Access Compliance Report Public Rights-of-Way (Curb Ramps)

Main Street: N/A		Cross Street: PUERTO_PL		Location:	E
ADA ID: RPRK220208153945	Ramp Type: Type 6 - Directional 1	Initial Pass/Fail: Pass	Overall Compliance: No	Severity Score:	2
Codes/Mitigation Info/Possible Solution			Field Measurements/Component Compliance

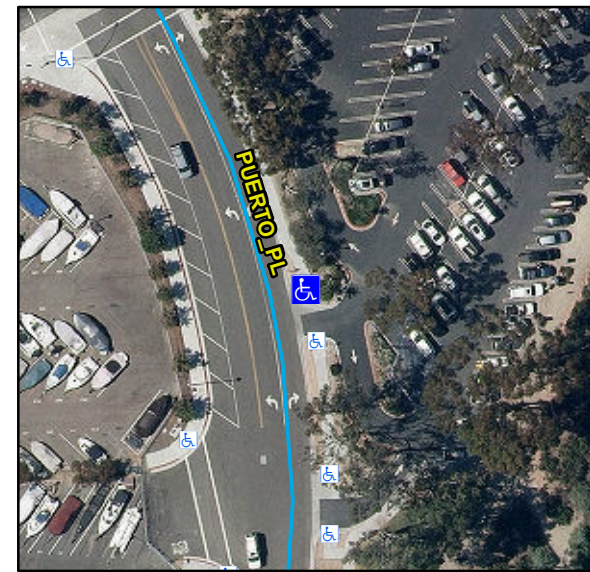
Gutter Ponding Observed.

R302.7, STD 1115
